30-40 DALTON STREET

(RD) RESIDENCE ZONE - D
CITY OF PORTLAND, MAINE
DEPARTMENT OF BUILDING INSPECTION

Subject: Application for amendment to
permit 47/2316 covering construction
of enclosed porch on front of dwelling
at 34 Dalton Street.

34 Balton Street—Amendment to building permit 47/2316 to cover one-story addition for dwelling house under construction for Nellie F. Libby by Walter Libby, contractor—9/20/47

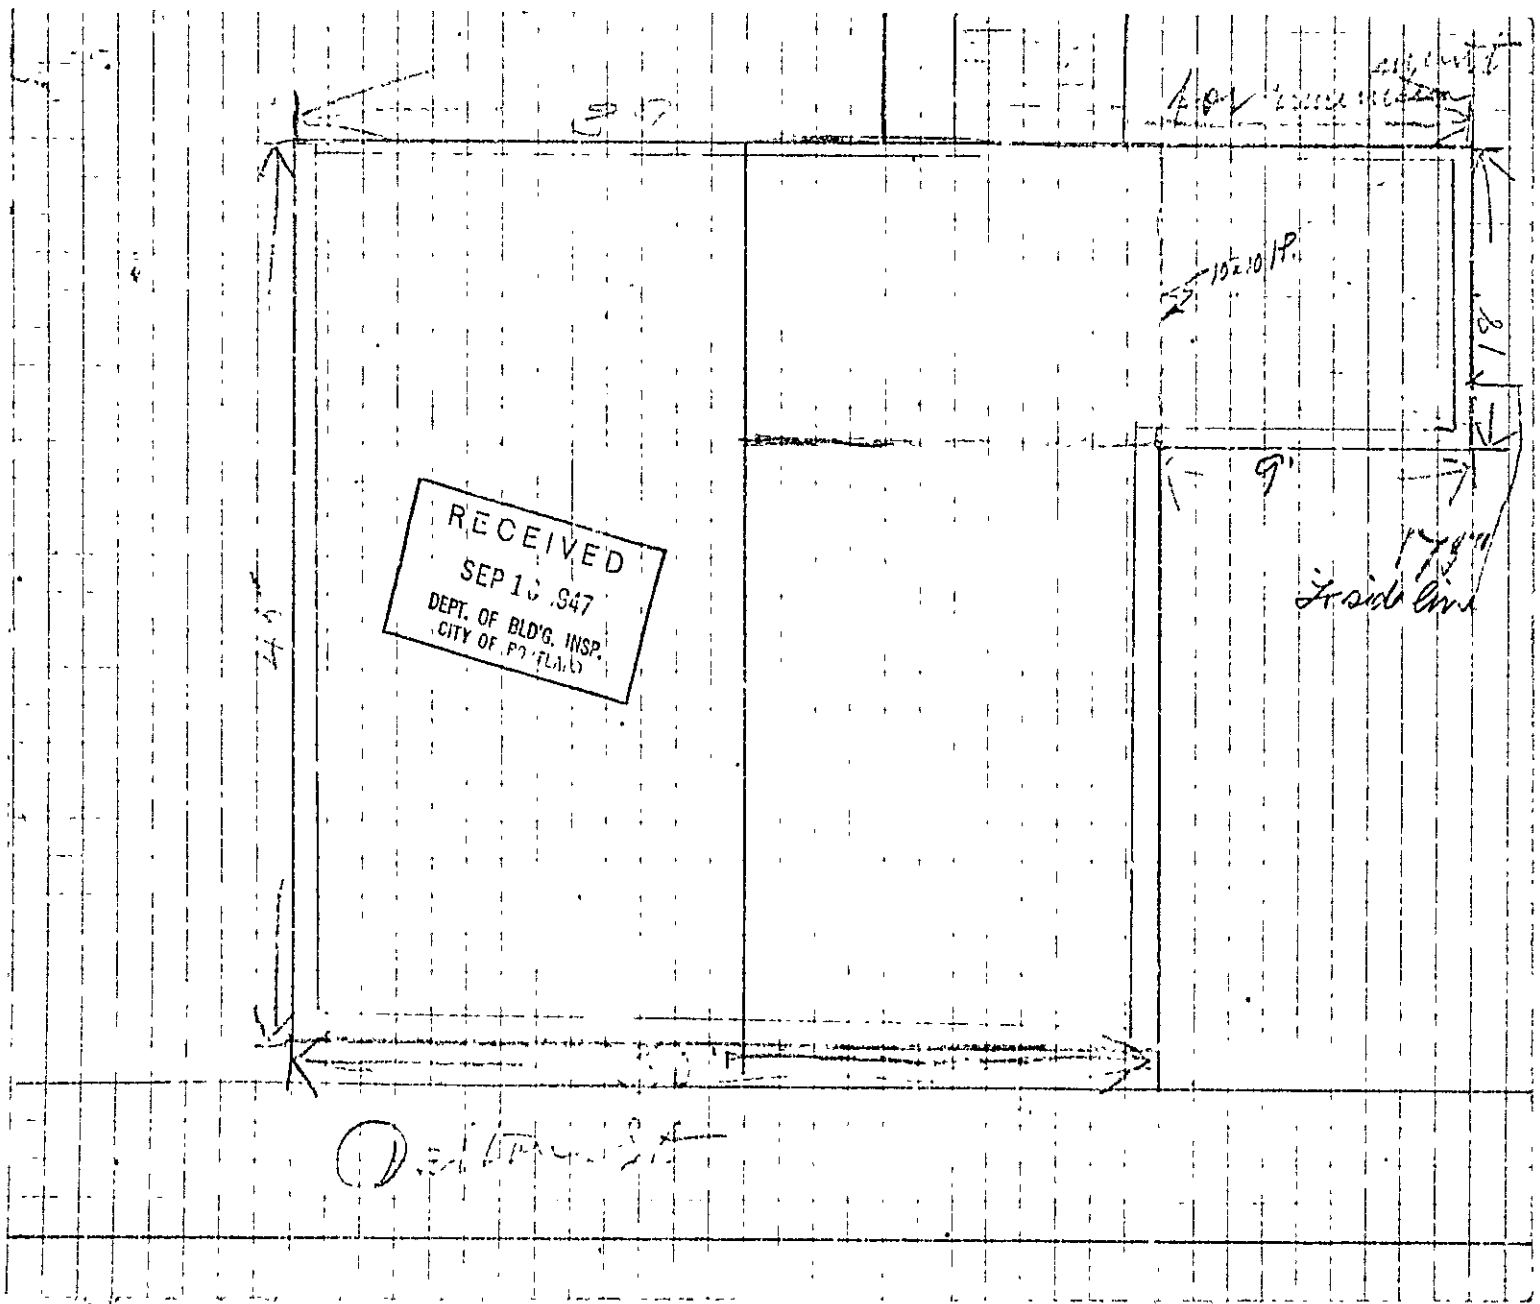
The 10x10 hard pine girder intended on a span of 13' between the proposed addition and the main house does not work out strong enough.

Mr. Libby should furnish more information to show whether or not the beam would support a partition overhead and if that partition in turn might support part of the roof of main house and proposed addition.

Whether or not this beam would support a partition above or any of the roof load, the 10x10 on a 13-foot span is not strong enough to support the floor load. A pier in the center of the 13-foot span would make it strong enough probably to support all loads, but Mr. Libby should indicate at this office or better still, by letter what he will do under this circumstance.

I thought it was fully understood that I should put 'n a pier under ~~center pier~~ ^{center pier}. There is no partition on it and it simply holds up the floor.

In regard to roof it will be steel or trussed to the satisfaction of your office. A hip roof and hips are carrying the load the amor weight is very small.

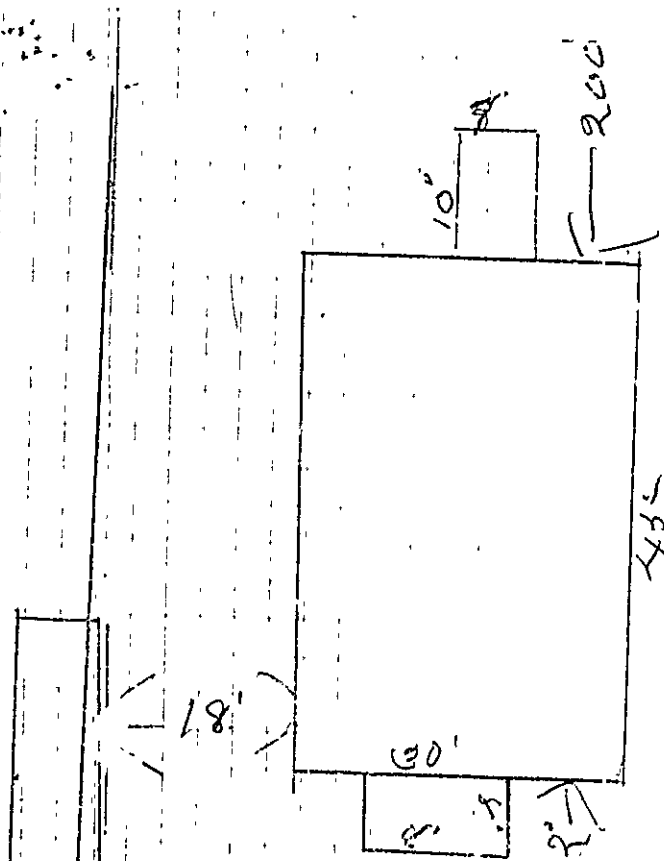
1. Sec. 5D of the Zoning Ordinance provides that the front wall of the dwelling shall set at least 12 feet from the street line of Dalton Street, and your location plan and staking indicates that the front wall would be just that distance from the street line. Your plan shows an 8-foot by 8-foot front entrance porch projecting into the required front yard. Section 15B of the Zoning Ordinance makes allowance for overachment of a one-story entrance porch not enclosed into such a required front yard but provides that such an entrance porch to be allowed must not exceed 50 square feet in area and must not project more than 16 feet from the building. I realize that you have told Mr. Sears that you will leave the porch off, but I cannot issue the permit on that basis as some type of entrance porch will be needed and we must know what you propose, how it is to be framed and what kind of a foundation it is to have and that must be shown on the plans before we have any concrete record of compliance with the ordinances and therefore before we can issue the permit on this score.

REQUIRED FRONT YARD = 15% of 90'-14"
OR
13.5' = 12' - O.K.
